# United States Patent and Trademark Office

APPLICATION NO.	FI	LING DATE	FIRST NAMED INVENTOR	ATTORNEY DOCKET NO.	CONFIRMATION NO.
10/783,479	(	02/20/2004	Larry D. Morris	2810	2140
36288	7590	08/19/2005		EXAMINER	
KENNETH		<	KOVACS, ARPAD F		
2121 MAPLE WICHITA, KS 67213				ART UNIT	PAPER NUMBER
,				3671	
			DATE MAILED: 08/19/2005

#### **DETAILED ACTION**

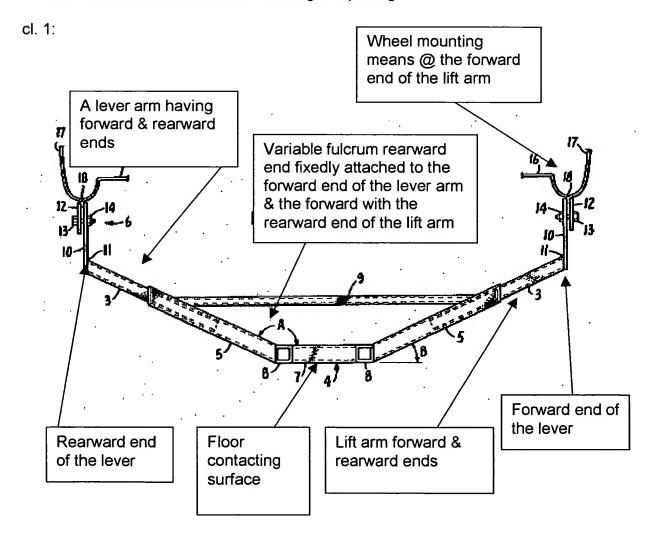
- (b) the invention was patented or described in a printed publication in this or a foreign country or in public use or on sale in this country, more than one year prior to the date of application for patent in the United States.
- 2. Claim 1 is rejected under 35 U.S.C. 102(b) as being anticipated by US Patent 4836739 of Cappelletto et al.

Prior art discloses vehicle/tractor lift/tilting comprising:

upon alternate levering & counter levering of the lever arm moving the floor contacting surface rearwardly toward the rearward end of the lever arm and forwardly toward the forward end of the lift arm.

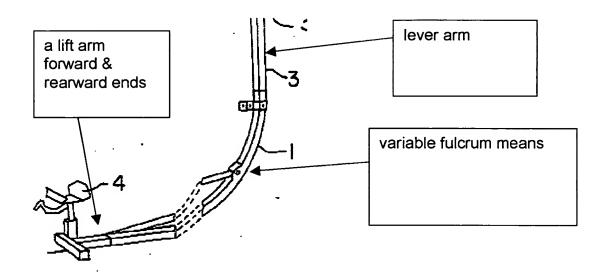
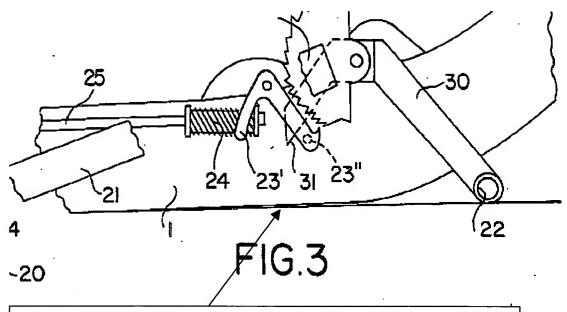
3. Claims 1-5 are rejected under 35 U.S.C. 102(b) as being anticipated by US Patent 4579505 of Lauritsen.

Prior art discloses:

cl. 1:

wheel mounting means / wheel carriage (4; col. 2, ln 53) fixedly attached to the forward end of the lift arm (as shown in the figure above);

a lever arm (3);

variable fulcrum means having a forward end fixedly or wholly formed with the rearward end of the lift arm, and a rearward end fixedly or wholly formed with the forward end of the lever arm (as shown in the figure above);

A floor contacting surface, upon alternate levering & counter levering of the lever arm moving the floor contacting surface rearwardly toward the rearward end of the lever arm and forwardly toward the forward end of the lift arm

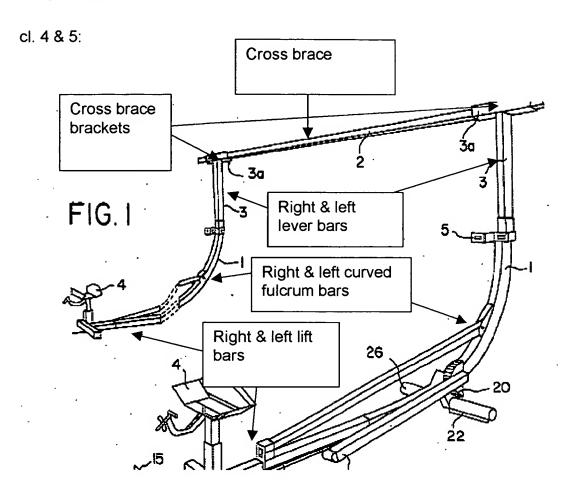
wheel mounting means comprises a tire cradle / wheel carriage (4; col. 2, ln 53);

wheel mounting means comprises:

Pivoting means connected **operatively** to the left and right ends of the cradle & forward end of the lift arm (tire pivots about mid point of the cradle)
